Norwich to Tilbury

Document: 9.5 Proposed Change Application 1: Overview Report -
Change Request 1 (Bulphan) (CA1)

Final Issue CA1

March 2026

THE NATIONAL GRID (NORWICH TO TILBURY) ORDER
 PROPOSED CHANGE ORDER LIMIT PLANS - CHANGE REQUEST 1
 PROPOSED CHANGE TO THE PROJECT ORDER LIMITS
 REGULATION 5(2)(o)
 SECTION H (SHEET C, THURROCK COUNCIL)

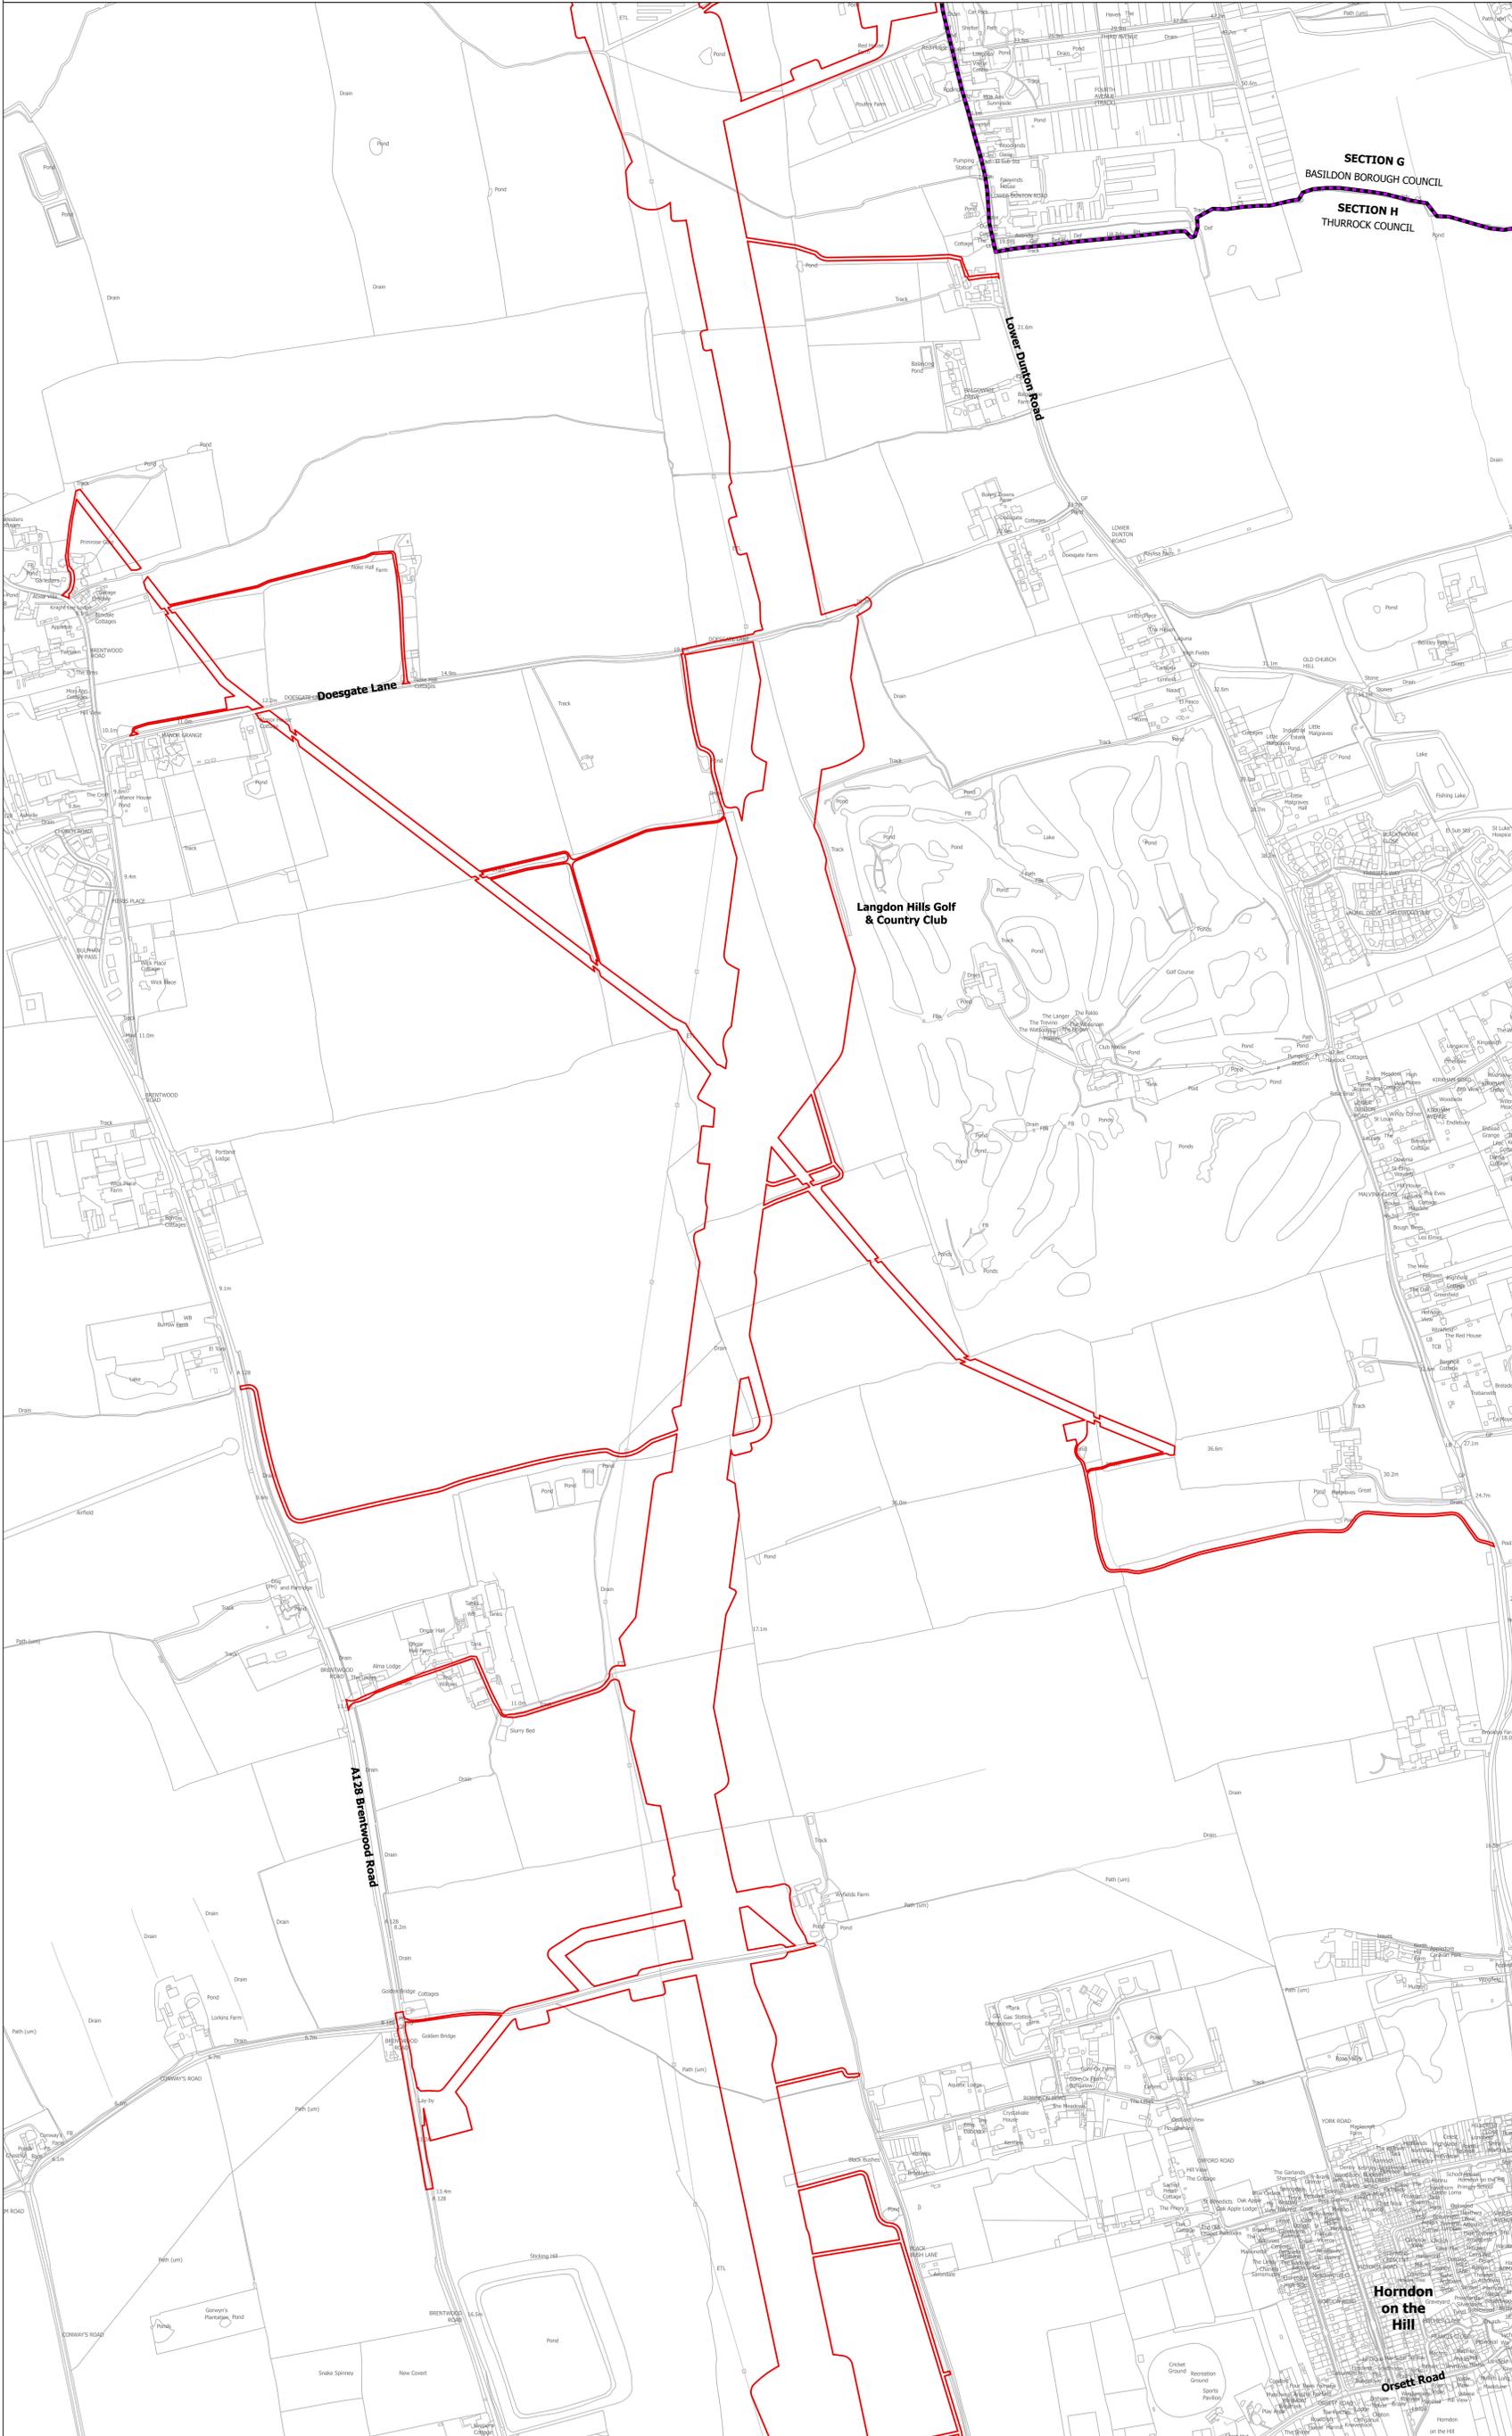
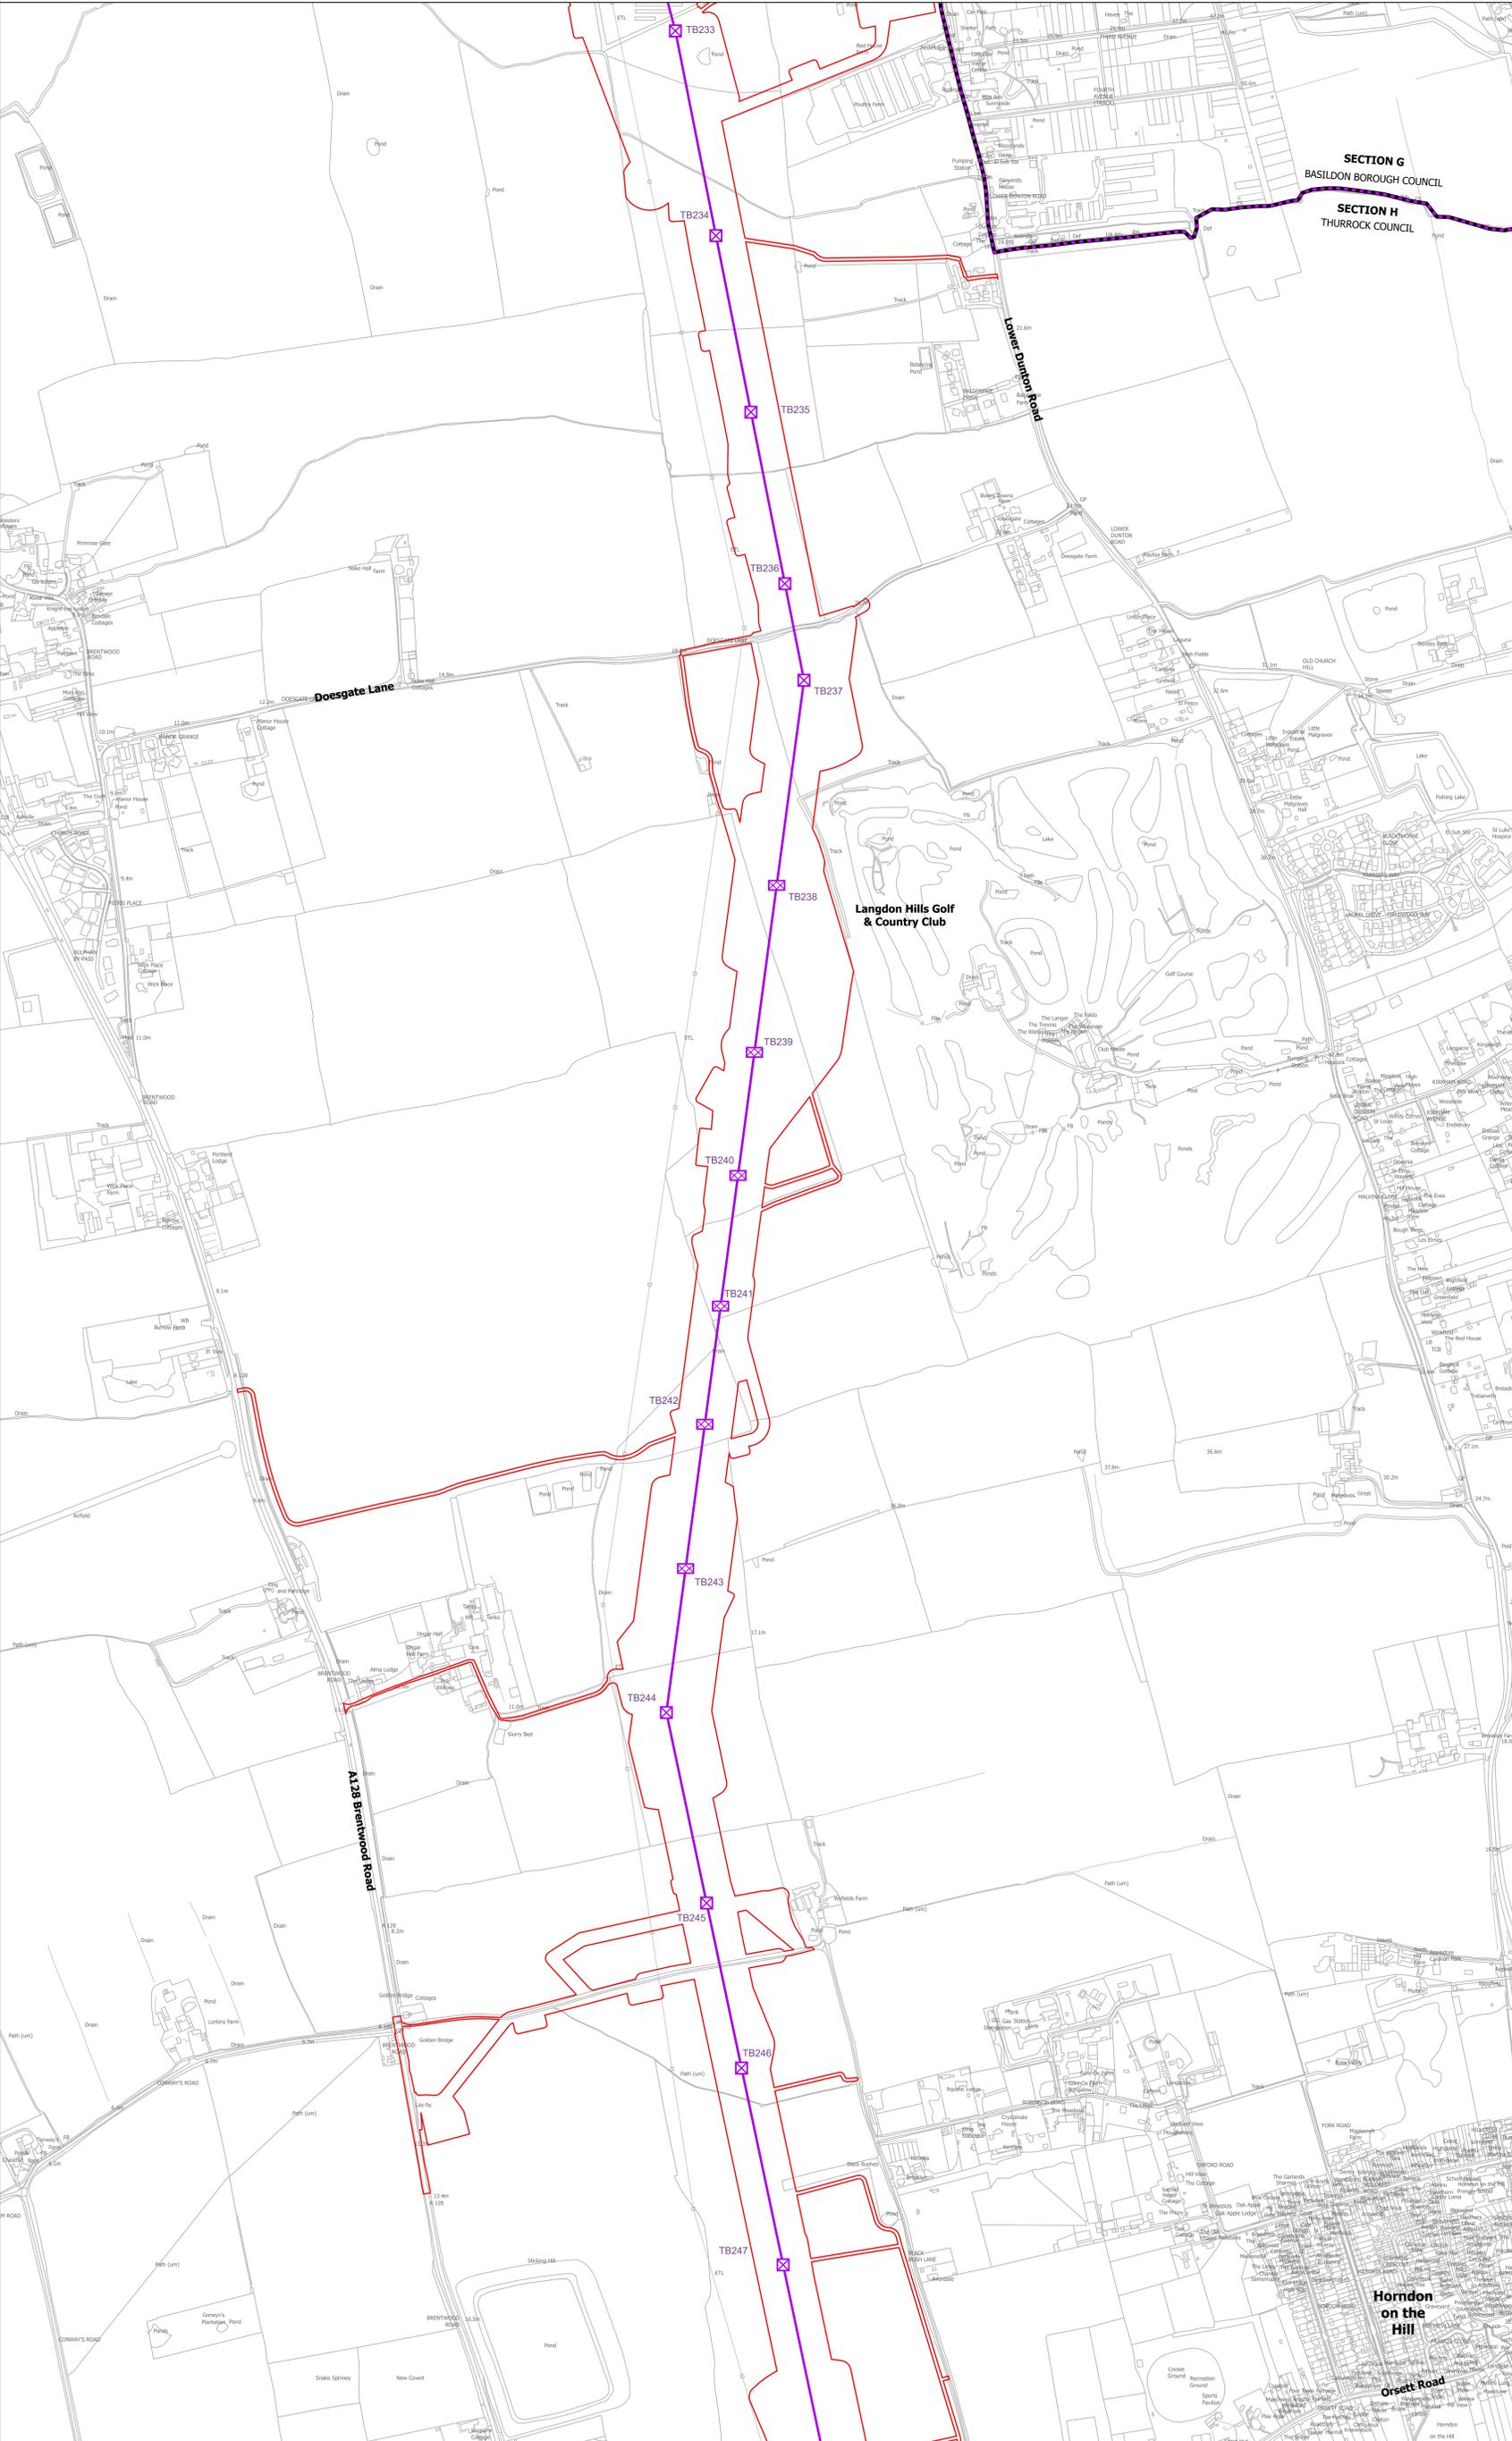
1.3.3 This document has been submitted to support Proposed Change Application 1 for Change Request 1 (Bulphan). Change Request 1 (Bulphan) relates to an increase in the Order Limits to facilitate works required for the protection of the existing Thames to Buncefield Multifuel Pipeline, west of Langdon Hills Golf Club. This proposed change responds to feedback concerning the potential for accelerated corrosion on existing buried metallic services received from the British Pipeline Agency Ltd (BPA) who act as the agent for the owner, United Kingdom Oil Pipelines Limited (UKOP). Further details about Change Request 1 (Bulphan) are provided in **Chapter 2** of this document.

- 2.1.3 Since submitting its application for development consent, the Applicant has continued engagement with the BPA as agent for UKOP (the owner of the Thames to Buncefield Multifuel Pipeline ('the Pipeline')). As a result of this engagement, the Applicant is proposing to incorporate a design change into the Project that seeks to address feedback raised by BPA in ongoing communication and within their Relevant Representation **[RR-0413]**. This design change is referred to as 'Change Request 1 (Bulphan)'. The change proposed applies to a very discrete geographical area of the Project and, as a consequence, the vast majority of the Project will remain entirely unchanged.
